Planning Statement

Juhring and Hobbs field, Saint Hill Road, East Grinstead

MSDC Ref: DM/25/2223

April 2026

Figure 1: OS Map Extract North Lodge, 1970

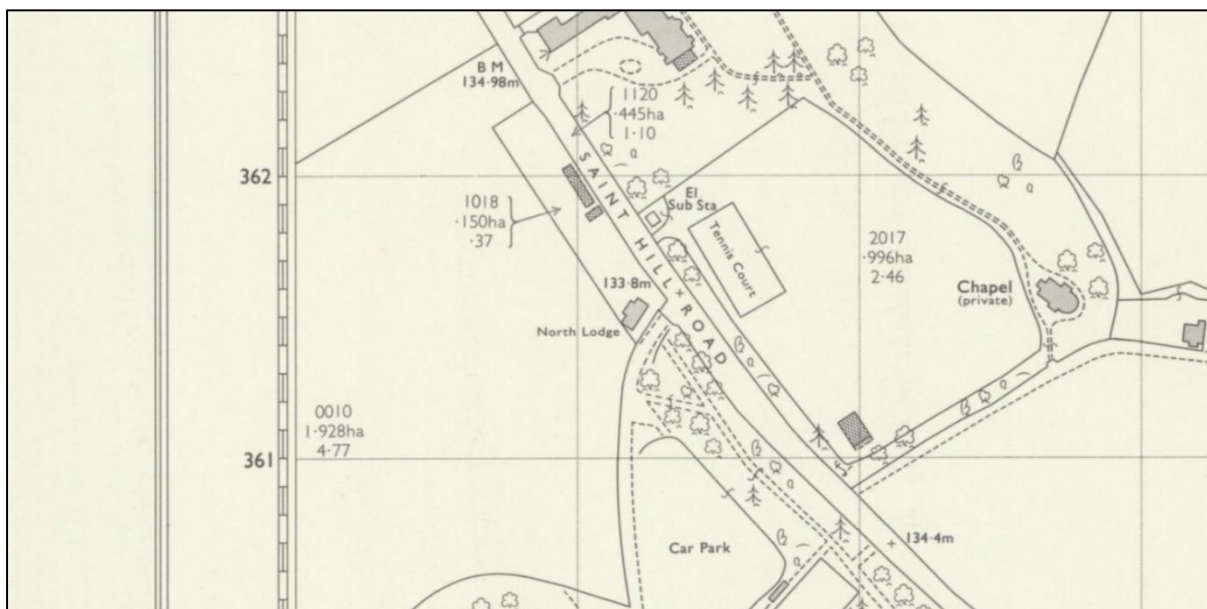
Regarding comments referring to North Lodge, the Conservation Officer is of the opinion that this building comprises a curtilage listed structure, forming part of the Grade II designation of *Saint Hill Manor*. The submitted Heritage Impact Assessment by WS Heritage confirmed that the building is not in fact curtilage listed, however, it would appear some further explanation is required. According to *Historic England Advice Note 10 – Listed Buildings and Curtilage* there are three key factors to be taken into account in assessing whether a structure or object is within the curtilage of a listed building:

North Lodge became fundamentally disconnected from Saint Hill Manor in 1959 when it was separated from the wider estate. A conveyance of the property occurred in 1959 between the Maharaja Sir Sawai Man Singh Bahadur, Broadland Properties Limited and Herbert Dennis Hall in May 1959 which resulted in North Lodge being separated from the estate and becoming a separate, private dwelling, no longer functioning as a lodge building as part of

Saint Hill Manor was first listed at Grade II on the 2nd of August 1972, therefore, North Lodge was not under common ownership and not in a function/use ancillary to the listed building at the time of listing. The property can also clearly be observed to have its own defined curtilage prior to the listing of Saint Hill Manor, as depicted by the Ordnance Survey map published in 1970 (**Figure 1**).

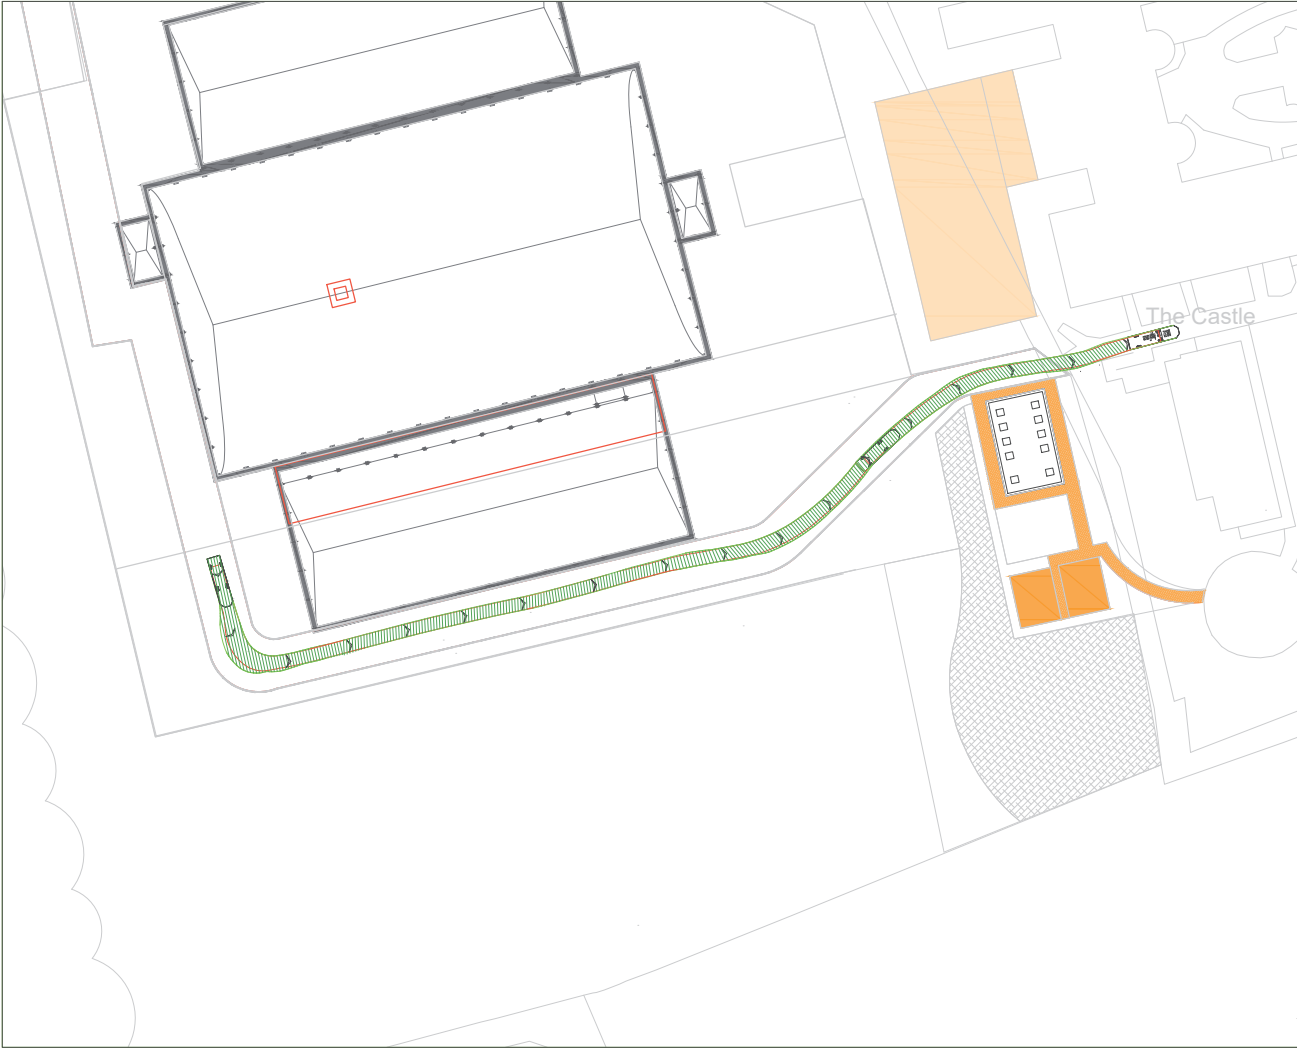
Comment - Transport

2.3.18 It is assumed these vehicles are hired for the event could this be clarified.

Pelham Transport Consulting Response
